# Access Compliance Report

## Public Rights-of-Way

### (Curb Ramps)

Intersection ID: 10030508	Main Street: LITTLE_GEM_LN	Cross Street: N/A	Location: NE
ADA ID: 6C9921ED654D	Ramp Type: BlendTrans1	Initial Pass/Fail: Fail	Overall Compliance: No
Severity Score: 12.5			
Codes/Mitigation Info/Possible Solution		Field Measurements/Component Compliance

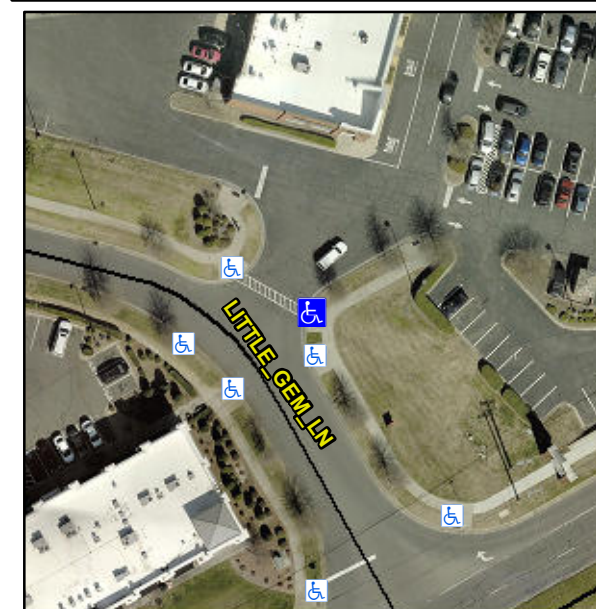
Compliance	Description	Data	Compliance	Description	Data
N/A	Ramp Length (in)	103.0	Yes	BlendTrans Slope (%)	4.6
Yes	Ramp Width (in)	49.5	No	BlendTrans XSlope (%)	6.5
N/A	Flare Type LT	N/A	N/A	Flare Type RT	N/A
N/A	Flare Slope LT (%)	N/A	N/A	Flare Slope RT (%)	N/A
N/A	Flare Traversable LT?	N/A	N/A	Flare Traversable RT?	N/A
N/A	Landing Length (in)	N/A	N/A	DWS Provided?	N/A
N/A	Landing Width (in)	N/A	N/A	DWS Contrast?	N/A
N/A	Landing Slope (%)	N/A	N/A	DWS Length (in)	N/A
N/A	Landing X Slope (%)	N/A	N/A	DWS Full Width?	N/A
N/A	Landing Curb? (Y/N)	N/A	N/A	DWS Offset (in)	N/A
N/A	Shared Landing?	N/A			
N/A	Gutter Ponding?	N/A	N/A	Gutter Slope (%)	N/A
N/A	Gutter Lip Ht (in)	N/A	N/A	Gutter X Slope (%)	N/A
N/A	Painted X Walk1?	Yes	N/A	Painted X Walk2?	N/A
	X Walk 1 Direction	To NW		X Walk 2 Direction	N/A
	X Walk 1 Width (in)	63.0		X Walk 2 Width (in)	N/A
	X Walk 1 Slope (%)	0.7		X Walk 2 Slope (%)	N/A
	X Walk 1 X Slope (%)	6.5		X Walk 2 X Slope (%)	N/A

N/A	Ramp inside XWalk1?	Yes	N/A	Ramp inside XWalk2?	N/A
	Road Slope (%)	5.4		Clear Space?	N/A
	Road X Slope (%)	2.7	N/A	Clear Space to XWalk (in)	N/A
N/A	Any Obstructions?	N/A	N/A	Storm Grate/Utility Hazard?	N/A
	Obstruction Type			Storm Grate/Utility Type	
		N/A			N/A
			Yes	Surface Condition? (G/P)	Good
			N/A	Curb Slope (%)	3.9

**Remove & Replace Curb Ramp With Two New Directional Ramps or Equivalent.**

**R304.5.3**
